MEMO

DATE: September 20, 2016
TO: Planning and Sustainability Commission
FROM: Sallie Edmunds, Central City Planning Manager
CC: Susan Anderson, Director and Joe Zehnder, Chief Planner
SUBJECT: CC2035 Worksession on September 27, 2016

SUBJECT: Central City 2035 - Scenic Resources Protection Plan

Map A1: New Chinatown/ Japantown Historic District Heights

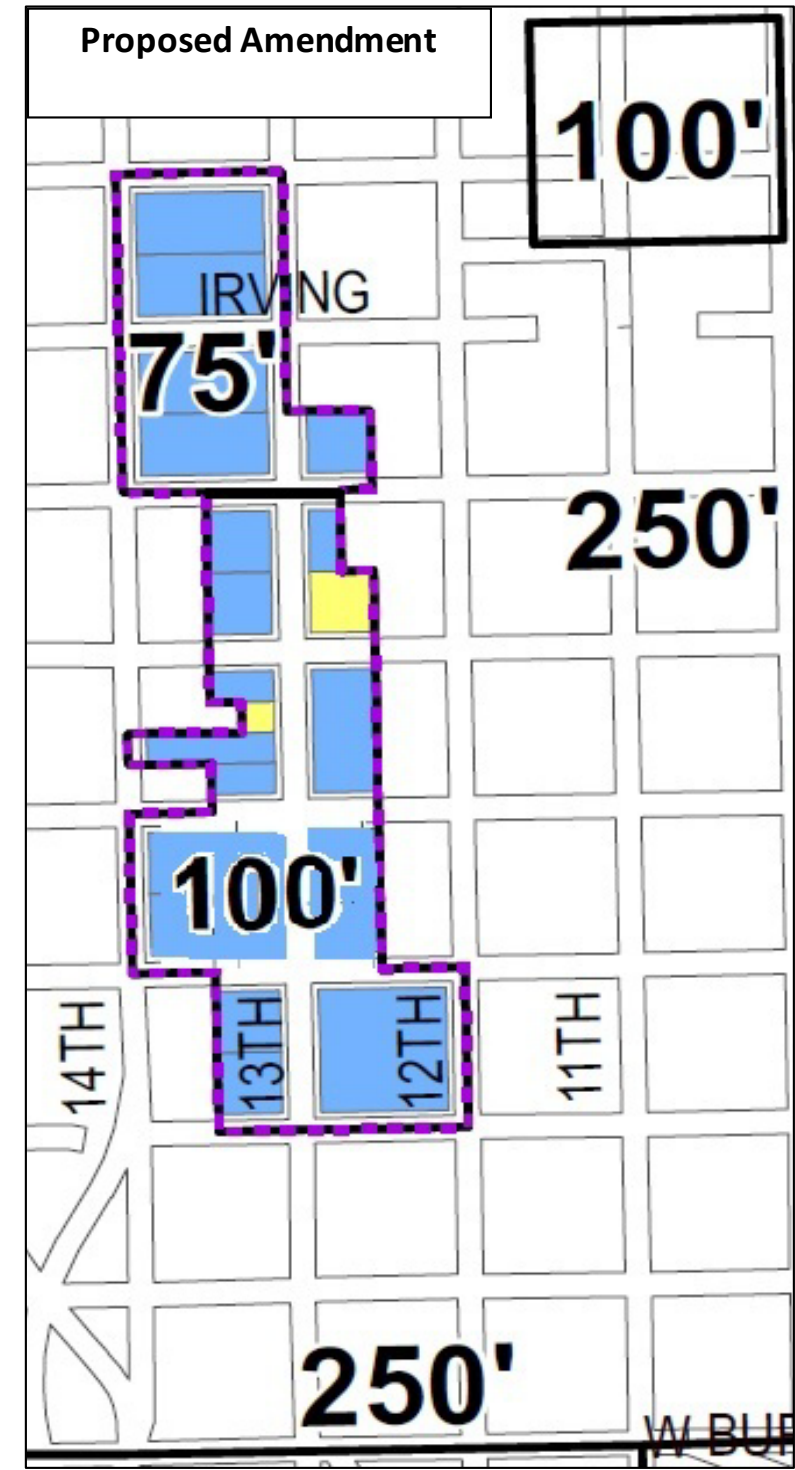
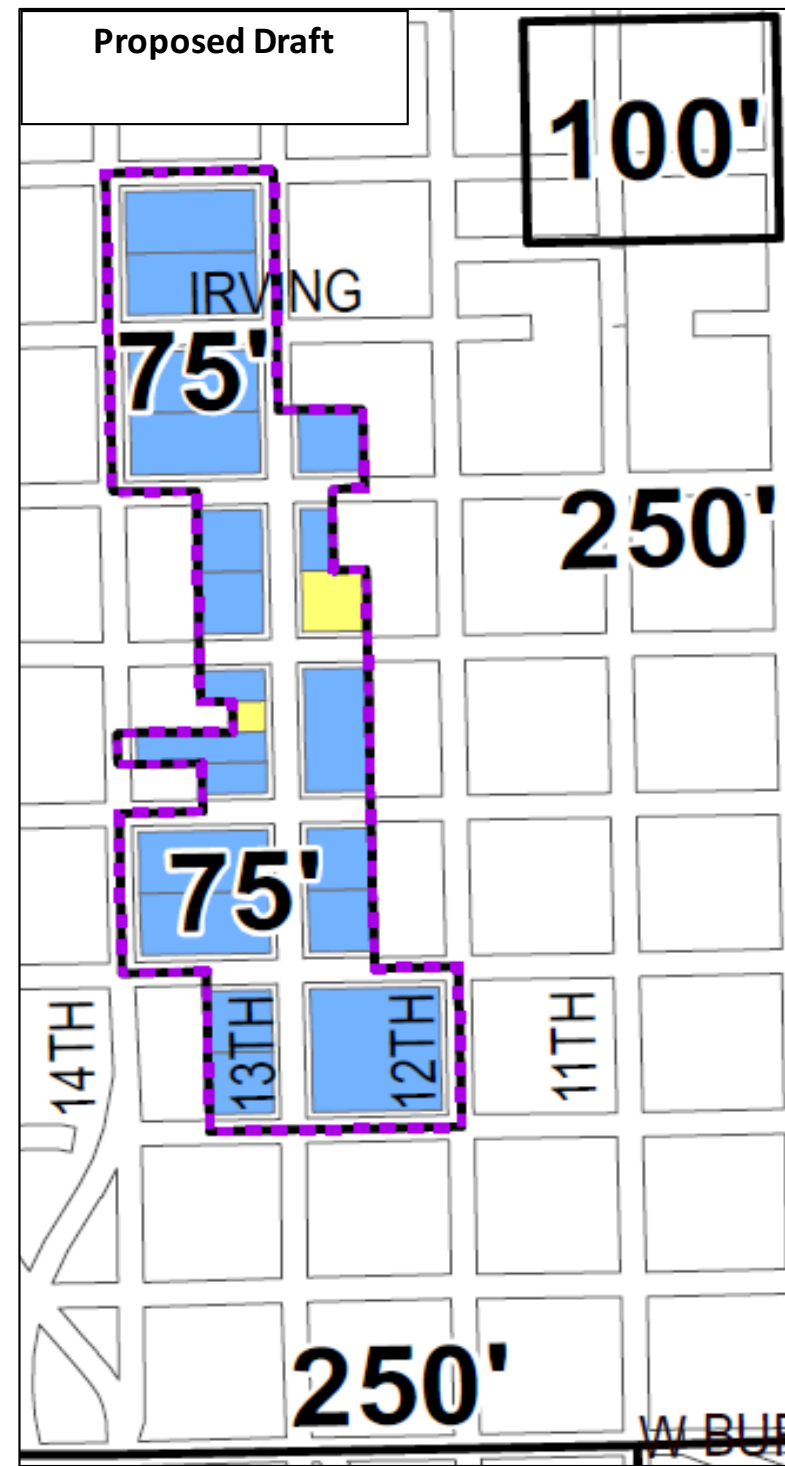
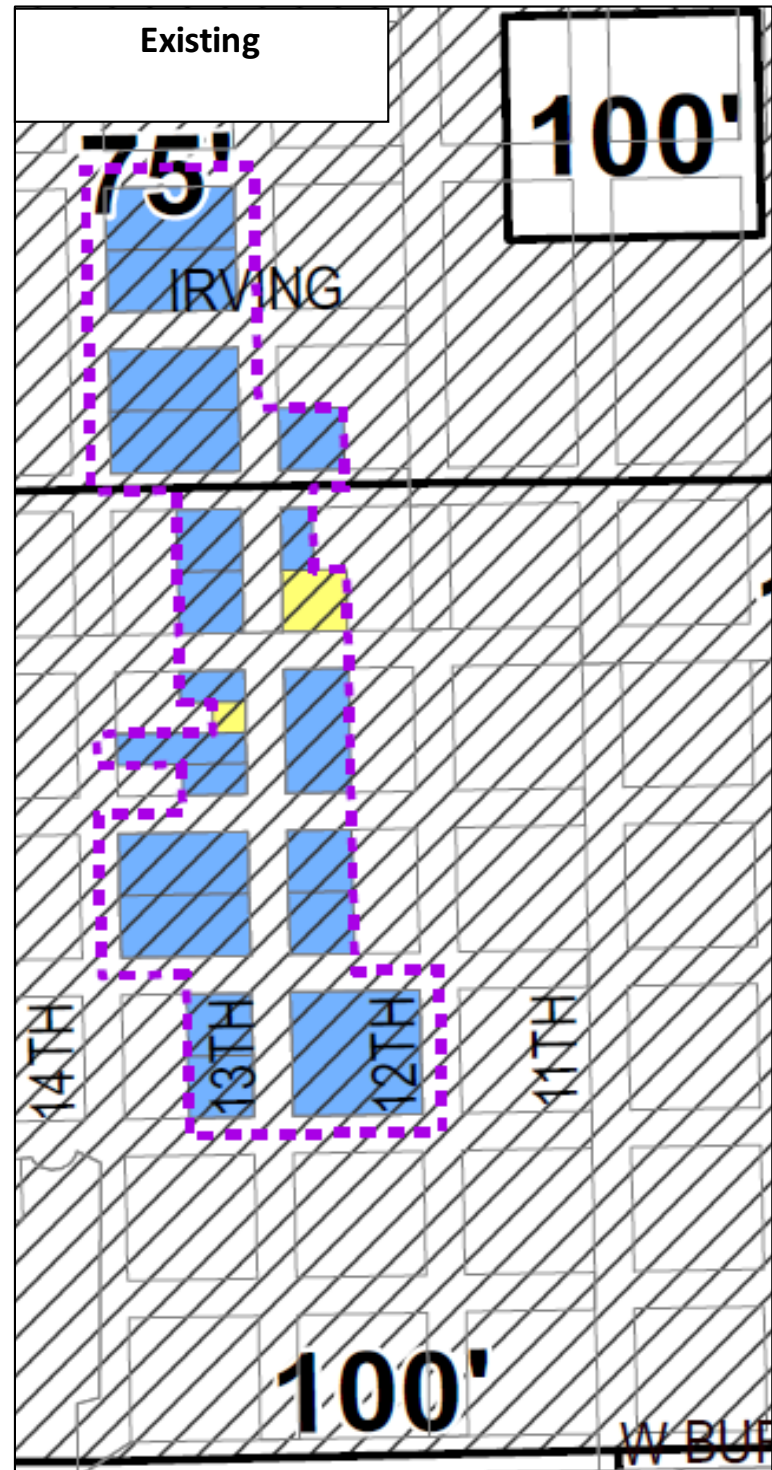
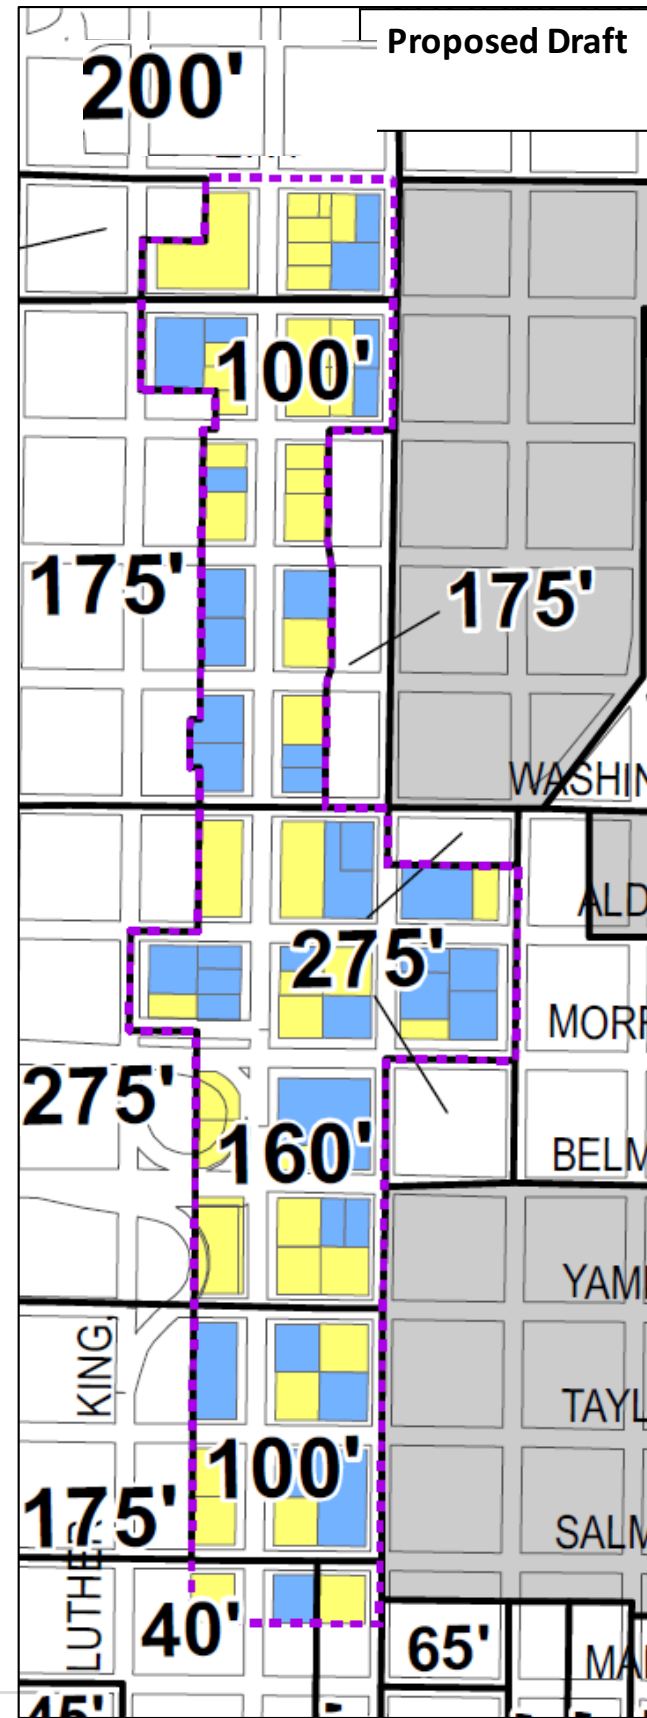
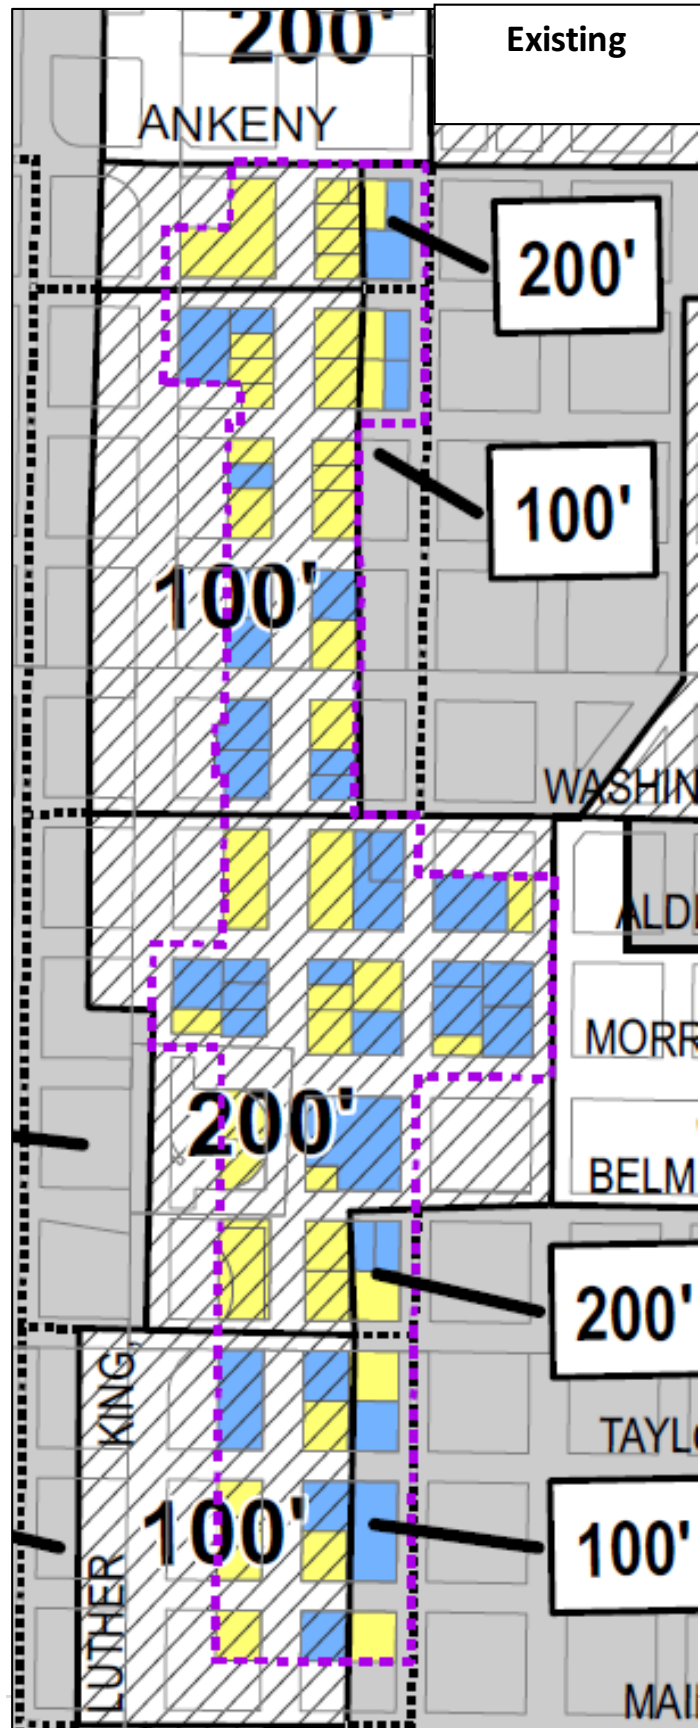
Ref #	Comment #	Commenter(s)	Historic District	Proposed draft	Request(s)	Staff recommendation	Staff rationale	Discuss?	PSC decision
A2 and Map A2	20865,	Albert Solheim,	NW 13th Avenue Historic District	NW 13th Avenue Historic District height of 75'. Reference: Map 510-3, p. 327	<ol style="list-style-type: none"> 1. Pearl District Neighborhood Association supports elimination of height bonuses and a maximum height of 100' in the south end and 75' in the north end of the historic district. 2. Property owner and owner representatives request returning heights to 100' in the south end and 75' in the north end of the historic district, as well as retaining height bonuses. 3. Portland Historic Landmarks Commission requests district-wide 75' height. 	Proposed Amendment: Increase the height in the NW 13th Avenue Historic District to 100' south of NW Hoyt Street, but otherwise affirm the district heights as presented in the Proposed Draft.	Although the Historic Landmarks Commission requested a 75' height in the historic district, the presence of contributing historic buildings at or above 75' in height and the testimony received from property owners interested in making seismic and other improvements necessitating rooftop additions to those taller buildings provide rationale for increasing to 100' the heights south of Hoyt Street.	<input checked="" type="checkbox"/>	<input type="checkbox"/> Support staff rec. <input type="checkbox"/> Other

Figure 6. Proposed 510-4 Bonus Heights

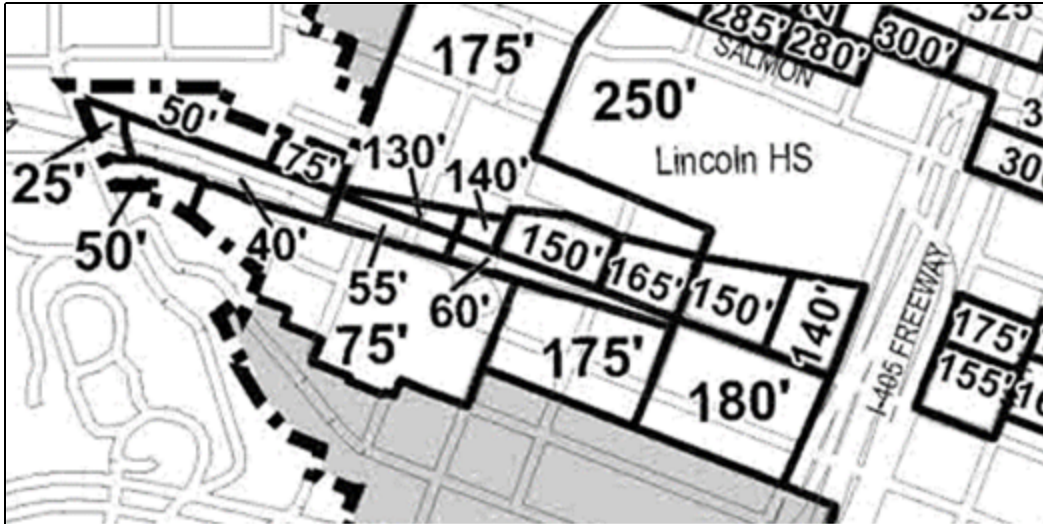
1. Allow 75ft heights along the north side of Jefferson St
2. Add a viewpoint at Collins Circle.

Along Jefferson St heights would be set at 75ft which allows 5-over-1 construction. This height supports commercial redevelopment planned for the street. This will slightly impact the view of Vista Bridge from the I405 overpass (see Figure 7).

Figure 8: Actions to Improve Pedestrian Connectivity at Collins Circle

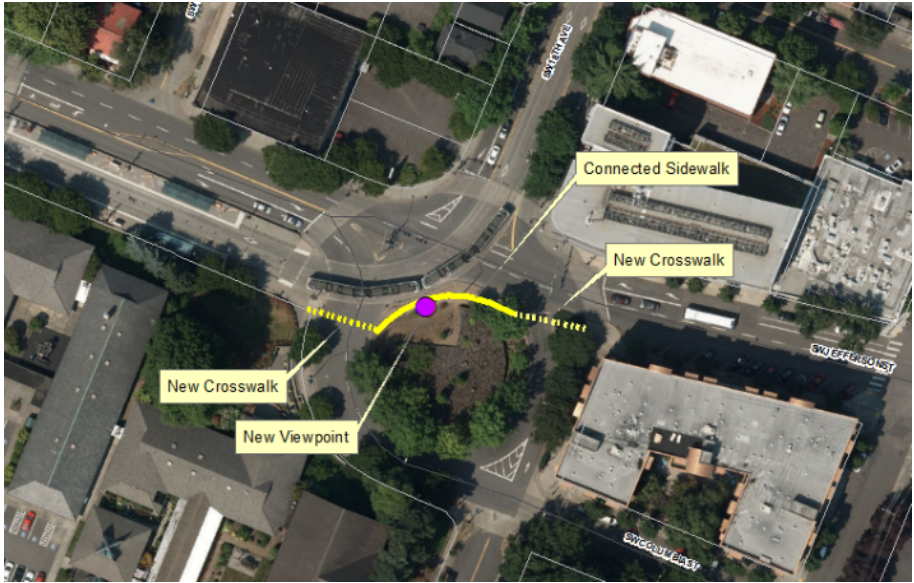
Because the view from the I405 overpass is primarily from auto or bike, it is recommended that a new viewpoint be added at Collins Circle.

Currently Collins Circle is underutilized. But with the addition of crosswalks, a sidewalk and vegetation maintenance at Collins Circle, this could become an attractive public open space with a view of Vista Bridge (see Figure 8). The view of Vista Bridge from Collins Circle is not impacted by 75ft height limits (see Figure 9).

Figure 11: Proposed Draft Map 510-4 Base Height

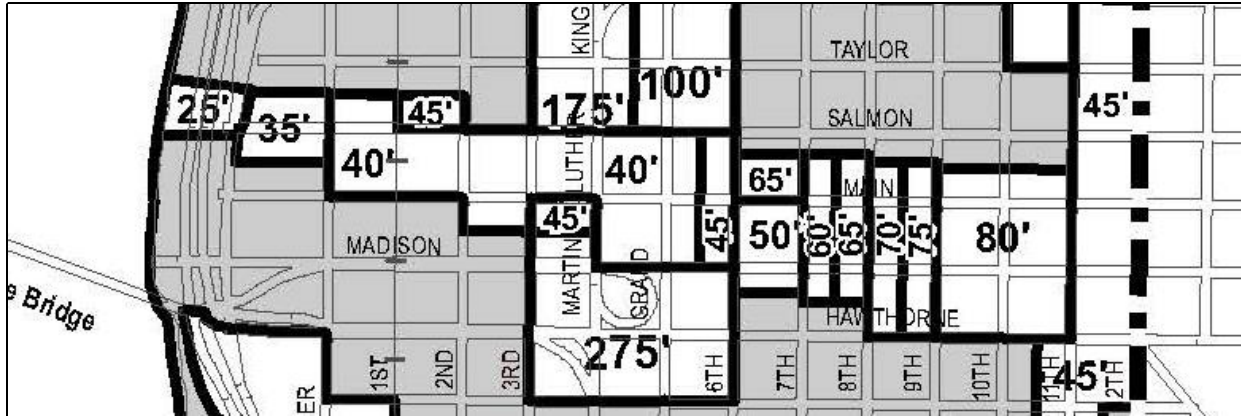
A lot of testimony was received concerning the impact of the view corridor to redevelopment in the Central Eastside. It was pointed out that not only are there impacts to sites that are identified in the BLI as vacant or underutilized; there are sites with one to three story buildings that today could be redeveloped up to 200 feet. Questions were raised about the fairness of bringing this proposal forward after the Southeast Quadrant Plan was completed. And questions were raised about the adequacy of the ESEE and if the proposal could result in takings.

Figure 11 shows the Proposed Draft base heights and Figure 12 shows the revised base heights. The economic impacts of the revised proposal, which are calculated only for the BLI sites in the view corridor, are \$10.9M in lost development potential and 1,512 in lost job capacity, as compared to the Proposed Draft which is \$15.6M in lost development potential and 2,166 in lost job capacity.

Figure 18: Proposed Draft Base Height Limits (map 510-3)

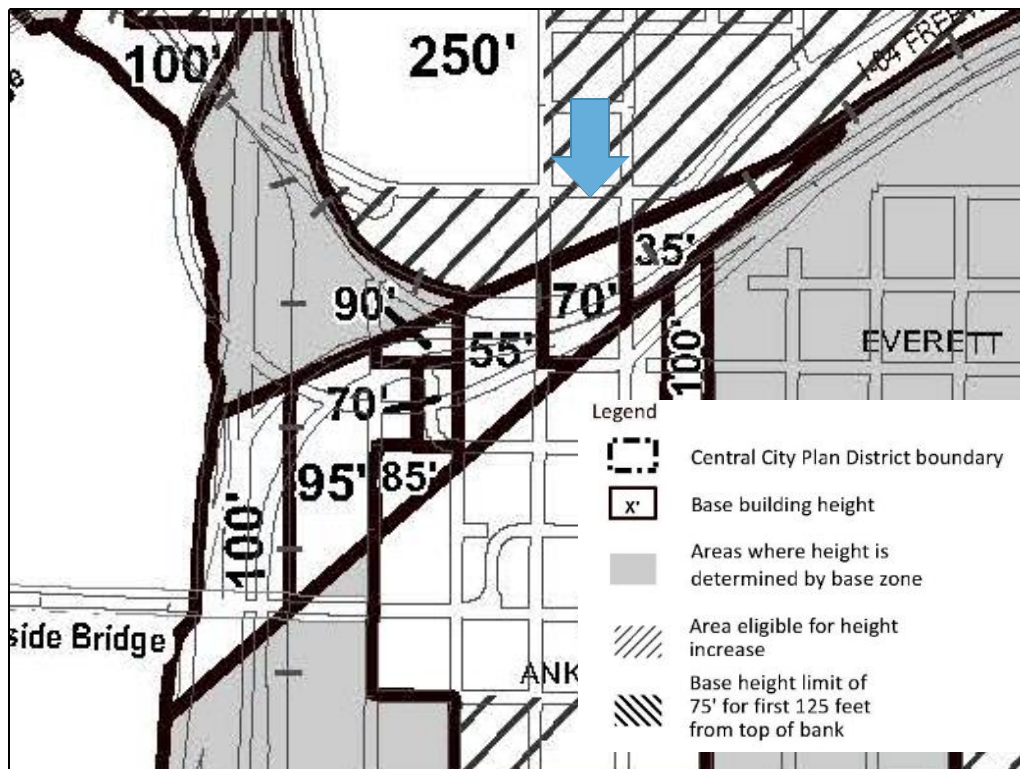
Public Comment

Retain Proposed Draft version (Figure 18).

By moving the viewpoint to a future bicycle/pedestrian bridge, half the property in question would be outside of the view corridor and the existing height restriction of 80 feet would be removed. The northern half of the site, approximately 24,000 sq ft (more than a half of a city block), would have a 250-foot base height limit with bonus to 325 feet. The remainder of the property, approximately 11,000 sq ft, would have a 70-foot height limit. This lower portion of the site is also on a very steep slope down to the railroad.

Figure 19: Proposed Height Limit at 306 SE Ivon Street

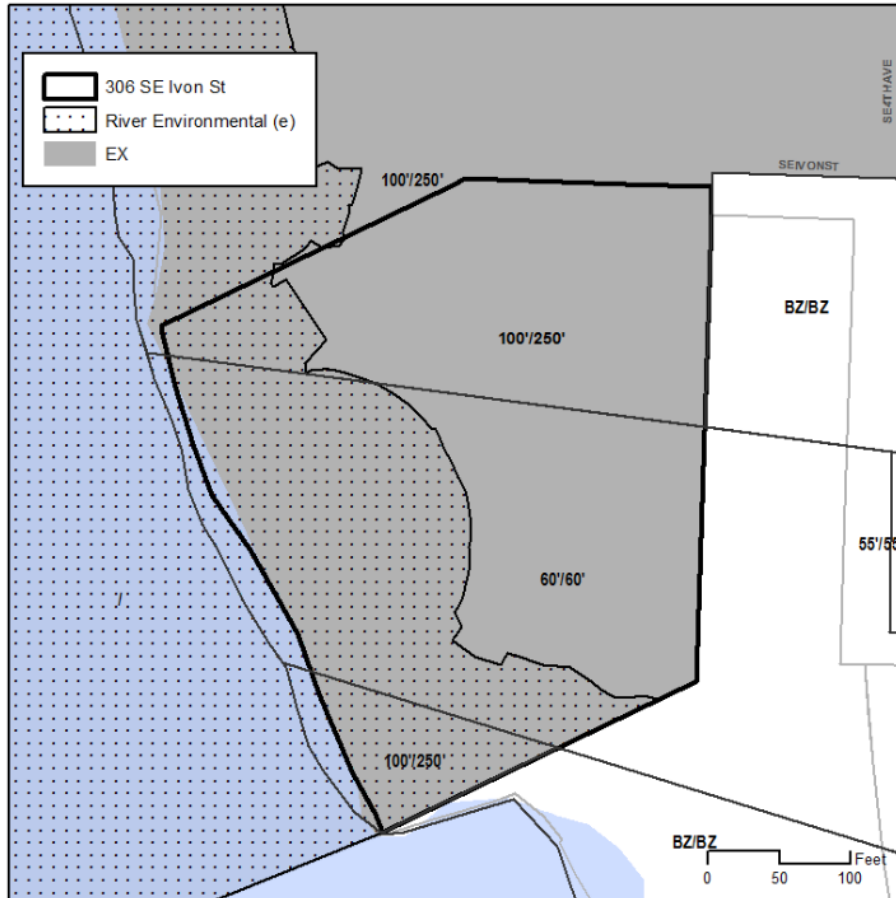
Public Comment

Retain Proposed Draft version (Figure 19).

The property is located along the Willamette River with access from SE Ivon Street. The site is 2.8 acres in size. The view corridor crosses the middle to southern portion of the site. The area outside of the view corridor and outside of the river e-zone is 0.9 acres (40,370 square feet). For reference, a typical city block in the Central City is 40,000 square feet.

The portion of the site outside of the view corridor and river e-zone is zoned IH today and proposed to be zoned EX. The height limit is currently based on the base zone. The proposed height limit is 100 feet with 3:1 FAR and an option to bonus up to 250 feet. The development could move the unused FAR from within the view corridor to outside the view corridor on the site and then bonus whatever else is needed to get the desired height outside the view corridor.

Figure 21: West Hills Viewpoints with DRAFT ESEE Decisions

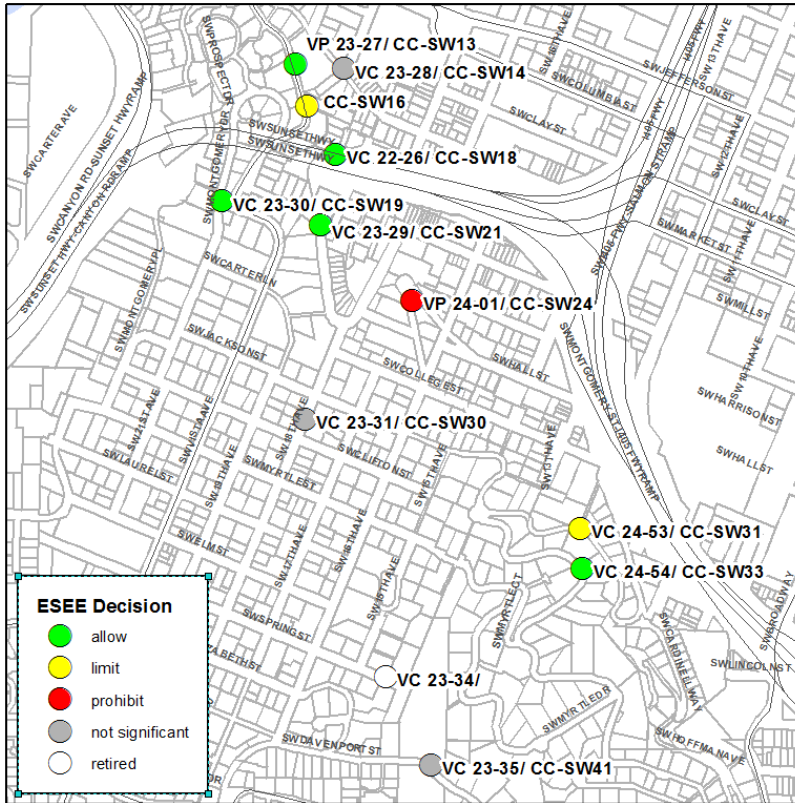
Testimony stated that all historic views from the West Hills should be protected and the views should be restored. Specifically, that SW14, which is located at the top of public staircase, should have a limit decision.

Other testimony stressed the importance of maintaining trees, particularly trees located on steep slopes.

Retain Proposed Draft version.

The proposal is intended to make it clear for which views tree removal, with replacement, should be allowed. The recommendation is limited to a few viewpoints in the West Hills in order to protect trees and the functions trees provide, especially on steep slopes. The proposal does not require tree pruning or removal. There is no obligation by the property owner; the code simply allows the tree removal.
